# Addendum Addenda

No./No
1

Project Description / Description de projet <b>M50 Room 066 Modifications / M50 Salle 066 Modifications</b>		
Project No./No de projet <b>6084</b>	Departmental Representative / représentant ministériel <b>Benoit Huot</b>	Date <b>26-Sep-2022</b>
Solicitation No./N° de sollicitation <b>22-58059</b>		
Notice: This addendum shall form part of the tender documents and all conditions shall apply and be read in conjunction with the original plans and specifications.		
Nota: Cet addenda fait partie intégrale des dossiers d'appel; toutes les conditions énoncées doivent être lues et appliquées en conjonction avec les plans et les devis originaux.

dwg.no. 6084-E02 dessin no.

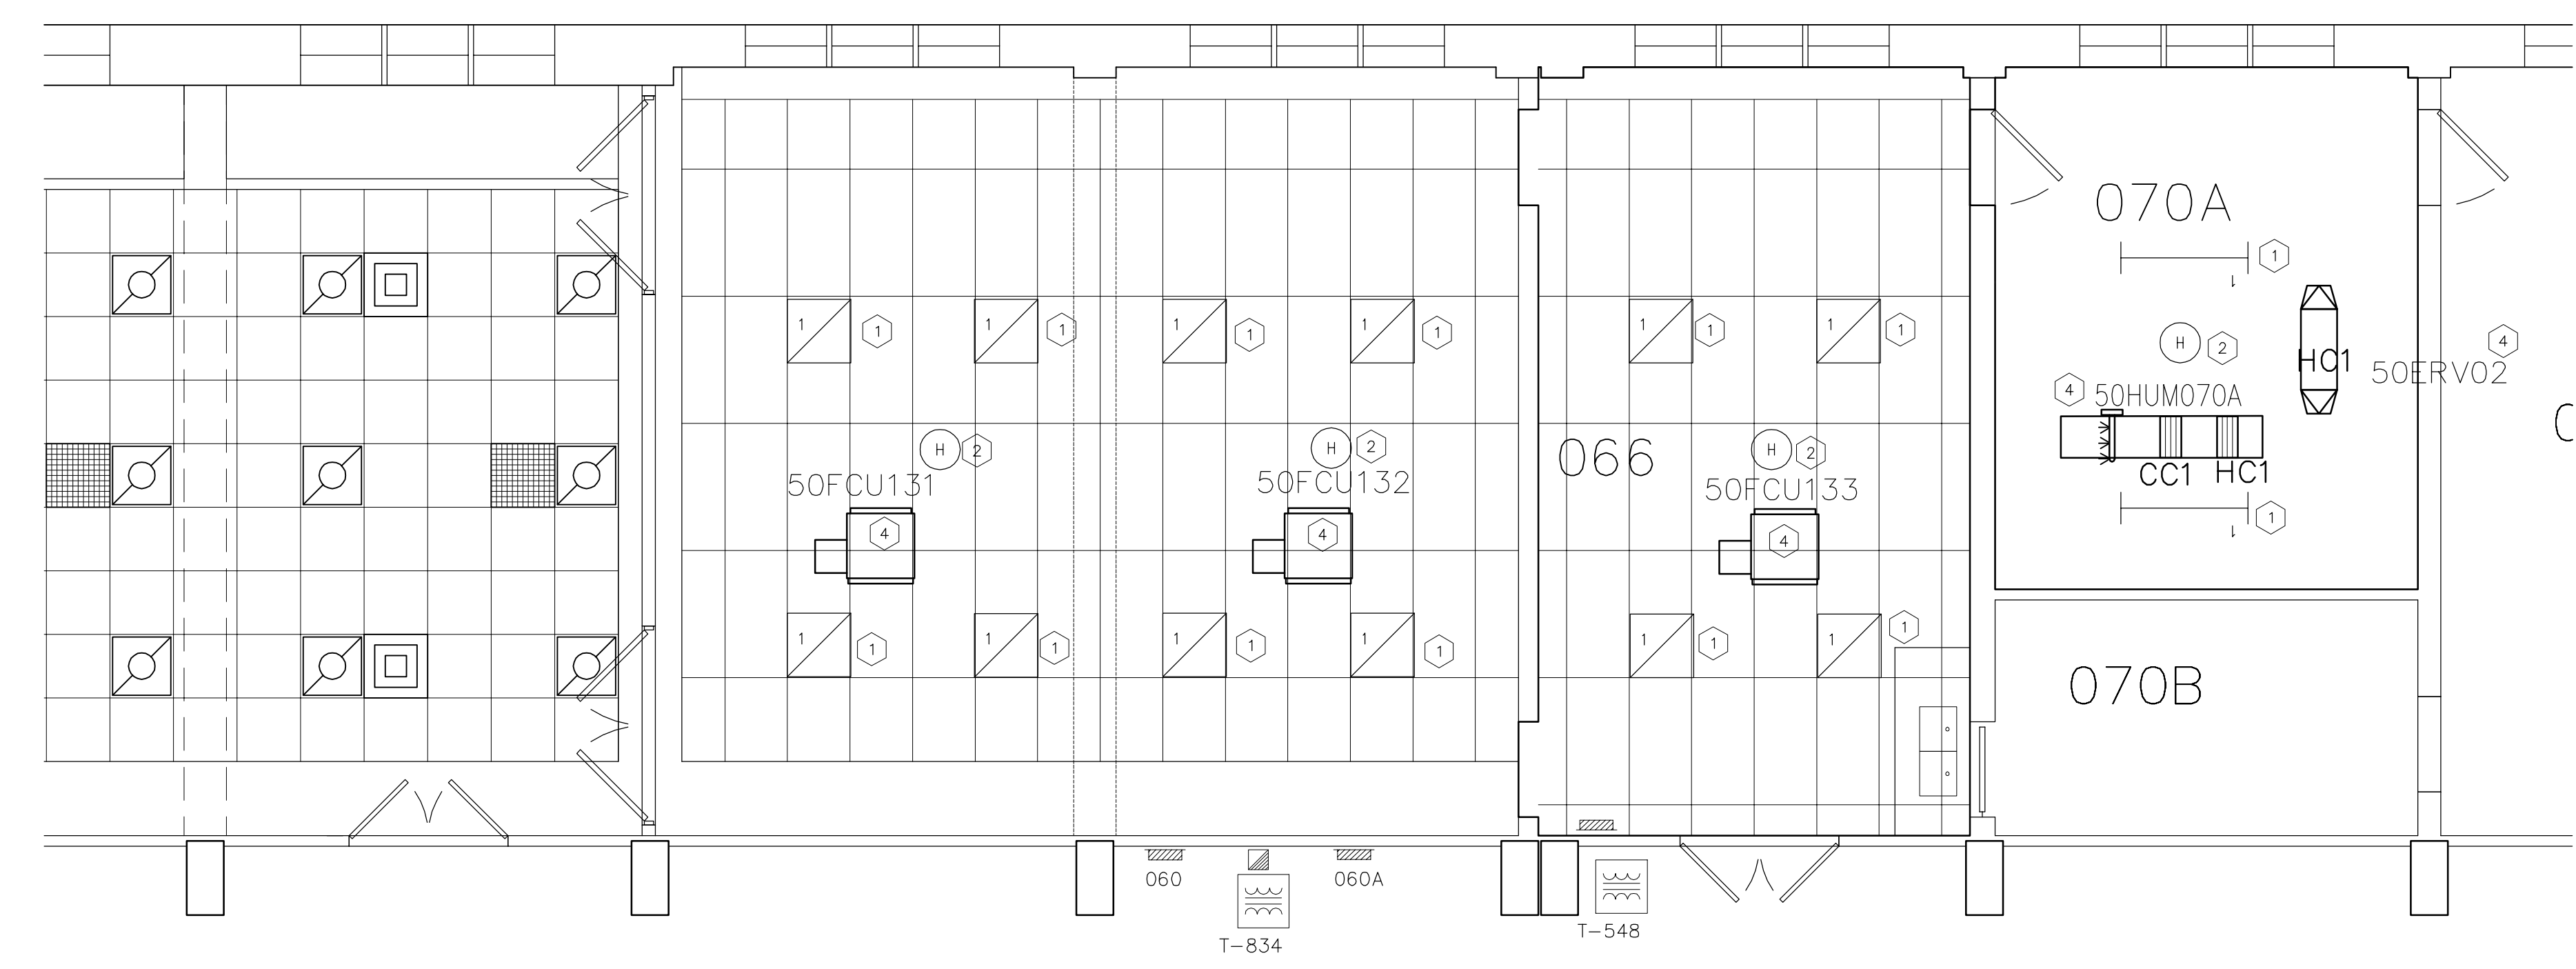
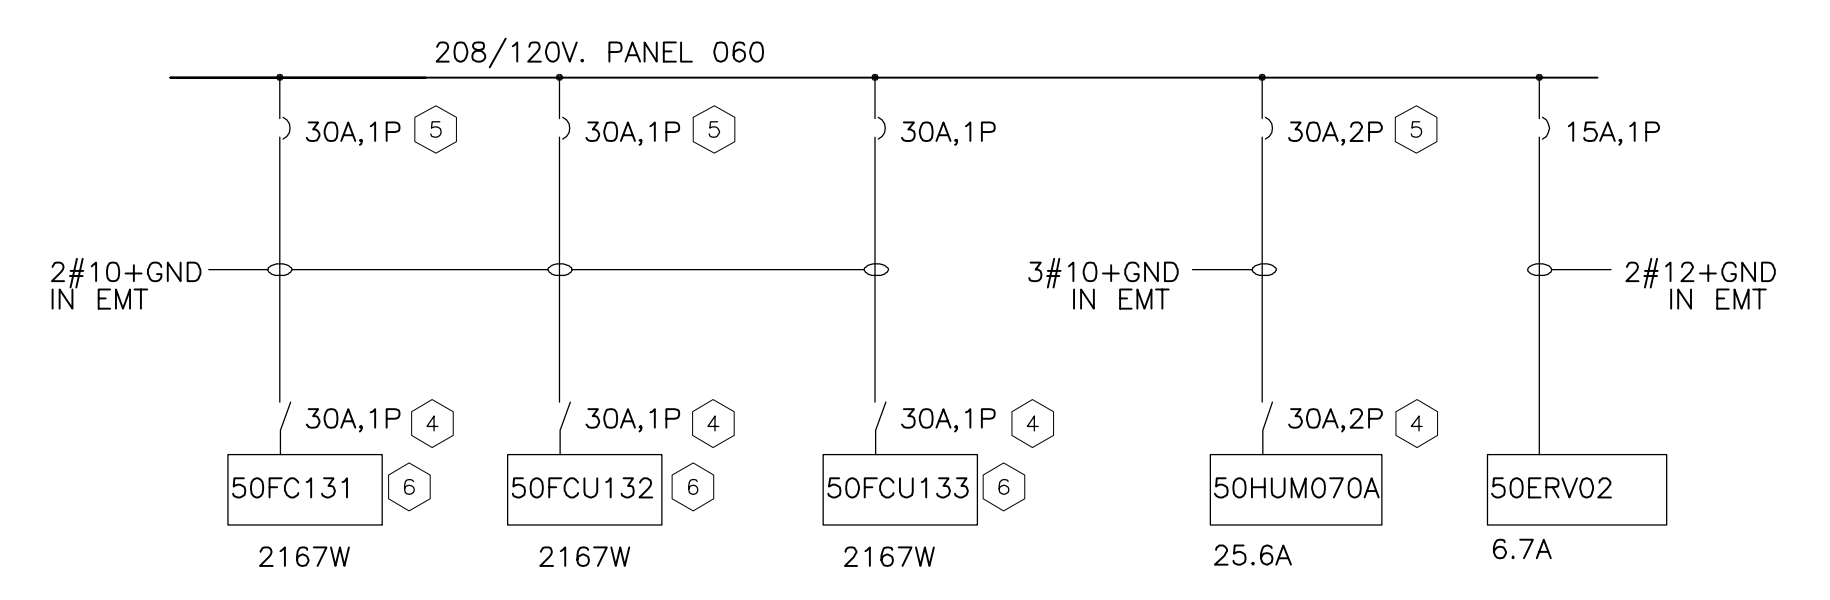
- 1.6      **Remove:** Dwg 6084-E01 Electrical New Work  
            **Replace with:** Dwg 6084-E02 Electrical New Work
